Item 9.1	Development Application DA.2020.1170 - 43 Multi Unit Dwellings, Onone Studio Dwelling and Strata Subdivision - Lot 339 DP1259563 - 67 Mary Street, Googong	
	<i>Attachment 1</i>	<i>DA.2020.1170 - 4.15 Assessment Report Matters for Consideration - 67 Mary Street, Googong.....2</i>
	<i>Attachment 2</i>	<i>DA.2020.1170 - Plans - 67 Mary Street, Googong 41</i>
	<i>Attachment 3</i>	<i>DA.2020.1170 - Draft Conditions of Consent - 67 Mary Street Googong..... 53</i>

ITEM 9.1 DEVELOPMENT APPLICATION DA.2020.1170 - 43 MULTI UNIT DWELLINGS, ONONE STUDIO DWELLING AND STRATA SUBDIVISION - LOT 339 DP1259563 - 67 MARY STREET, GOOGONG

ATTACHMENT 1 DA.2020.1170 - 4.15 ASSESSMENT REPORT MATTERS FOR CONSIDERATION - 67 MARY STREET, GOOGONG

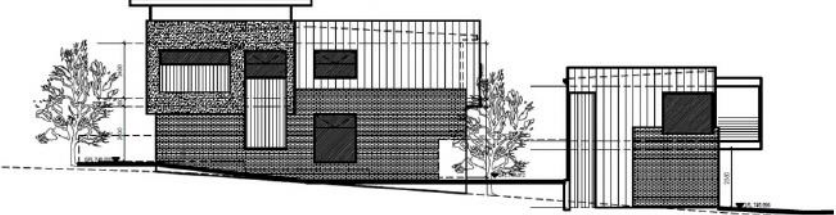
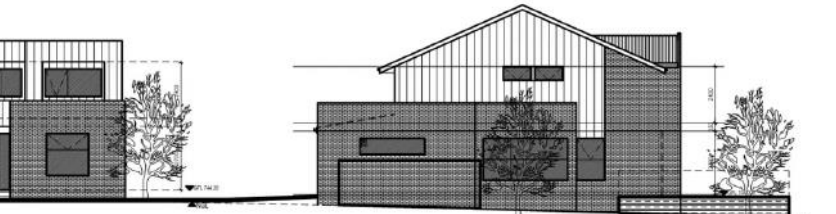
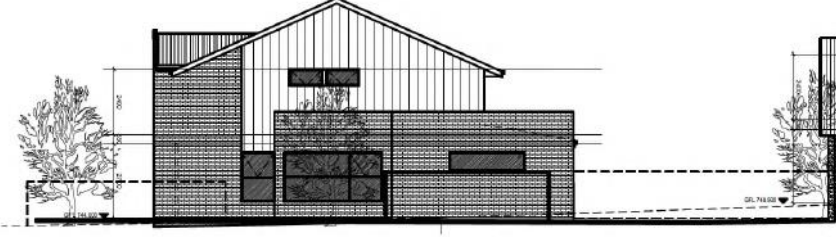
<p>Figure 15: Material schedule (Prepared by Tomi Milin)</p> <p>c) New buildings shall adhere to the minimum building line setbacks as set out in relevant Tables in this Part.</p> <p>Refer to assessment against Table 2.</p> <p>d) On corner sites the façade treatment should address both street frontages in order to promote a strong and legible character while maintaining sight lines.</p> <p>The development will encompass the entire subject site and will have corner frontages to 4 streets: Albion Street, Mary Street, Gorman Drive and Wellsvale Drive.</p> <p>Each unit will address the street whilst still maintaining an acceptable corner frontage. No solid walls are proposed for the elevations on the corner units and with additional landscaping it is considered that the development will not have a significant impact on the streetscape.</p>

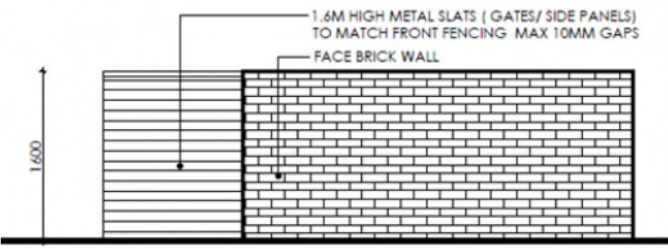
<p>Communal waste bin enclosures are proposed to be located at the front of the development on Albion Street and Gorman Drive. Fencing to a height of 1.6m (metal slats and face brick wall) is proposed to be located to the frontage of the enclosures. Landscaping to the front of the enclosures is also proposed to ensure that the bin enclosures do not dominate the streetscape.</p>

GOOGONG DCP COMMENTS	COMPLIES (Yes/No)
 <p>F4: TO WASTE ENCLOSURES</p> <p>Council's Waste Officer provided information for waste requirements and amended plans were received providing detail that each waste enclosures will accommodate 16 bins providing a total of 48 bins for the 44 units and allowing for 4 green waste bins.</p> <p>Detail has been provided on the plans that a 2m pathway is proposed connecting the waste enclosures to the kerb and with a minimum 2m opening into the enclosures.</p> <p>Trucks for the collection of waste are proposed to utilise the on-street parking facilities (visitor car parking spaces). To ensure that the trucks will have access to the bins, signage will be required that the car parks cannot be used on the designated collection days. Council Development Engineer has advised that the consent is to contain a condition that a Traffic Control Devices Plan is to be submitted to Council for review by Local Traffic Committee (LTC) prior to Construction Certificate and that the implementation of the plan approved by LTC is to be completed prior to issue of an Occupation Certificate. The Traffic Control Devices Plan is to address on-street parking controls to ensure that satisfactory lay-bys exist for the garbage trucks on bin collection day.</p> <p>A condition will also be contained within the consent that a Waste Management Plan is to be submitted for the construction of the development and for on-going waste management.</p>

Figure 27: Encroachments NH 2 Structure Plan – North Facing Private Open Space

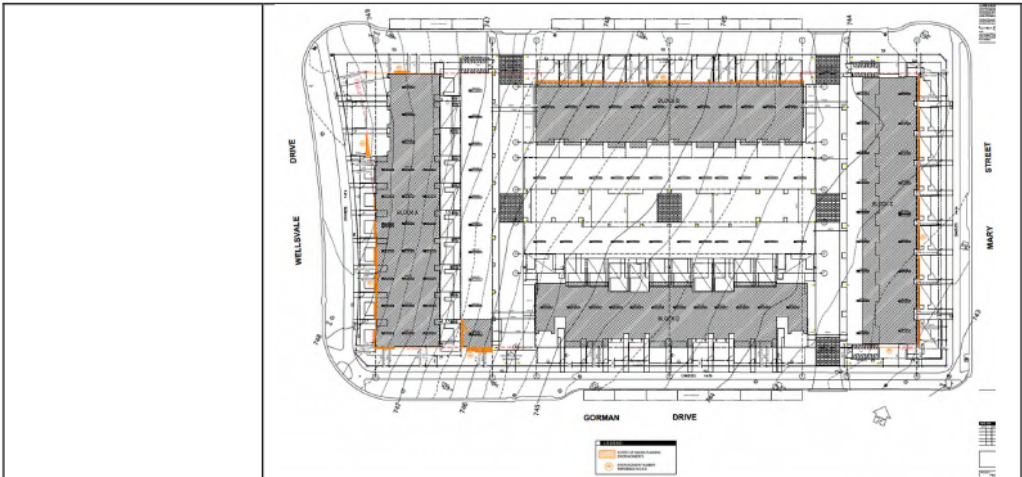
<p>reducing the minimum lot width for multi dwelling housing to 20.0 metres where the development application for the subdivision includes a dwelling design for each lot, and where it can be demonstrated the design is not inconsistent with the building form and design criteria set out in Section 7.4 of this DCP.</p> <p>Lot widths exceed the required minimum of 25m. Complies</p>
<p>Site coverage max</p>	<p>Multi Dwelling Housing - 50%</p> <p>48%. Complies.</p>
<p>Building height</p>	<p>As per QLEP 2012</p> <p>8.4m (at the highest point from natural ground level). Complies.</p>
<p>Front setback minimum</p>	<p>Multi Dwelling Housing - 4.0 metres where principle private open space is not located within the front setback. - 6.0 metres where principle private open space is located within the front setback.</p> <p>The proposals seeks a variation for encroachments to the front setbacks. A request for variation to these controls has been made by the applicant who has listed the following:</p> <ul style="list-style-type: none"> • <i>Encroachment 1- Just a 600mm pop out to single storey 3.1m long- This encroachment breaks up the 2 storey wall facing Albion Street so an articulation element which also provides a possible day bed / bench to add amenity internally (plus north Facing).</i> • <i>Encroachment 2- An angled single storey encroachment into the front setback of an angled front boundary line- Given the setbacks are varied along this frontage addressing the main road would provide some visual interest in the form an slightly angled presence as viewed from the busy street.</i> • <i>Encroachment 3 - Just a 600mm upper floor cantilevered element to add articulation to the street frontage- Could be removed however believe this only adds to the current street presence.</i> • <i>Encroachment 4 - Just a 600mm upper floor cantilevered element to add articulation to the street frontage- Could be removed however believe this only adds to the current street presence.</i> • <i>Encroachment 5 - 1000mm upper floor Stair and Studio over encroachment 6.3m wide on a 126m frontage. Developer has requested a Studio be added to reinforce corner and ideally offer increased mix and opportunity.</i> • <i>Encroachment 6 - 60mm single storey encroachment.</i> • <i>Encroachment 7 - Just a 450mm upper floor cantilevered element to add articulation to the street frontage- This setback needs to be 6m for POS which is achieved on the Ground floor- The overhang provides an eave over the window and adds articulation.</i> • <i>Encroachment 8 - Just a 250mm upper floor cantilevered element to add articulation to the street frontage- This setback needs to be 6m for POS which is achieved on the Ground floor- The overhang provides an eave over the window and adds articulation.</i> <p><i>The 3D images indicate the buildings are well articulated and the have no adverse streetscape impact- Many of the encroachments are small and add or are articulation elements.</i></p> <p>Although multiple variations have been requested, the encroachment on the setbacks are considered to be minor (see figure 25).</p>

Each Block of units has been designed with a different façade and materials and the development has been designed with sufficient articulation and landscaping that would minimise any impact created by the encroachments.
